Access Compliance Report

Public Rights-of-Way

Intersection ID: 43182	Main Street: PATTONSBURG_DR	Cross Street: RAVANNA_DR	Location: E
ADA ID: E475D940E3E5	Ramp Type: BlendTrans1	Initial Pass/Fail: Fail	Overall Compliance: No
			Severity Score: 33.75

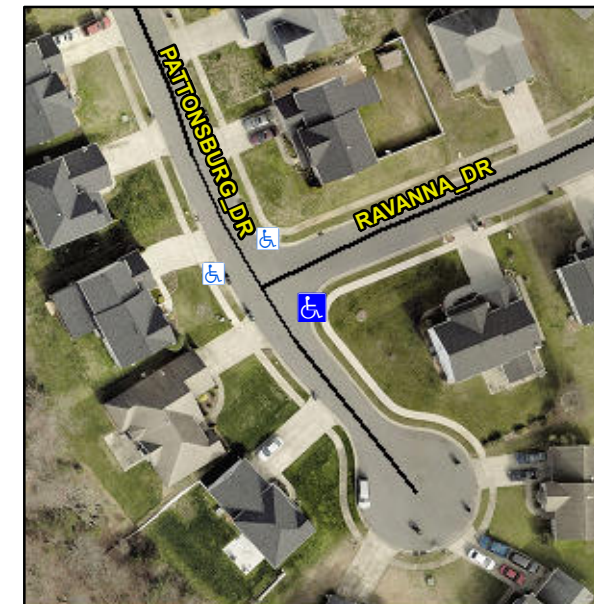
Not Found, R304.5.1, R304.5.3

Compliance	Description	Data	Compliance	Description	Data
N/A	Ramp Length (in)	48.0	Yes	BlendTrans Slope (%)	4.0
No	Ramp Width (in)	37.5	No	BlendTrans XSlope (%)	8.6
N/A	Flare Type LT	N/A	N/A	Flare Type RT	N/A
N/A	Flare Slope LT (%)	N/A	N/A	Flare Slope RT (%)	N/A
N/A	Flare Traversable LT?	N/A	N/A	Flare Traversable RT?	N/A
N/A	Landing Length (in)	N/A	N/A	DWS Provided?	N/A
N/A	Landing Width (in)	N/A	N/A	DWS Contrast?	N/A
N/A	Landing Slope (%)	N/A	N/A	DWS Length (in)	N/A
N/A	Landing X Slope (%)	N/A	N/A	DWS Full Width?	N/A
N/A	Landing Curb? (Y/N)	N/A	N/A	DWS Offset (in)	N/A
N/A	Shared Landing?	N/A			
N/A	Gutter Ponding?	N/A	N/A	Gutter Slope (%)	N/A
N/A	Gutter Lip Ht (in)	N/A	N/A	Gutter X Slope (%)	N/A
N/A	Painted X Walk1?	No	N/A	Painted X Walk2?	No
	X Walk 1 Direction	To N		X Walk 2 Direction	To S
	X Walk 1 Width (in)	N/A		X Walk 2 Width (in)	N/A
	X Walk 1 Slope (%)	7.6		X Walk 2 Slope (%)	1.4
	X Walk 1 X Slope (%)	0.7		X Walk 2 X Slope (%)	8.7

Remove & Replace Curb Ramp With Two New Directional Ramps or Equivalent.
